MODELS:

1996 - 1998 (AB) Ram Van
1996 - 1998 (AN) Dakota
1996 - 1998 (BR/BE) Ram Truck
1998 (DN) Durango
1996 - 1998 (ZJ) Grand Cherokee
1996 - 1998 (ZG) Grand Cherokee (International Markets)

This bulletin involves installing a newly designed governor pressure sensor.

FIGURE 1

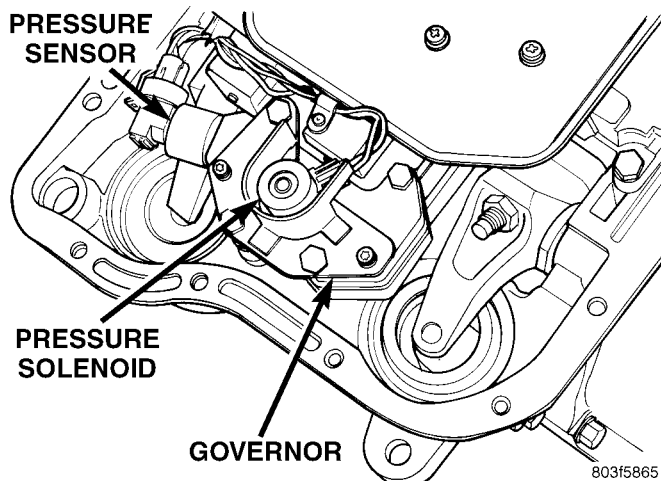
- 1. Following the procedures in the applicable service manual, replace the governor pressure sensor with p/n 56041403AA (Figure 1).
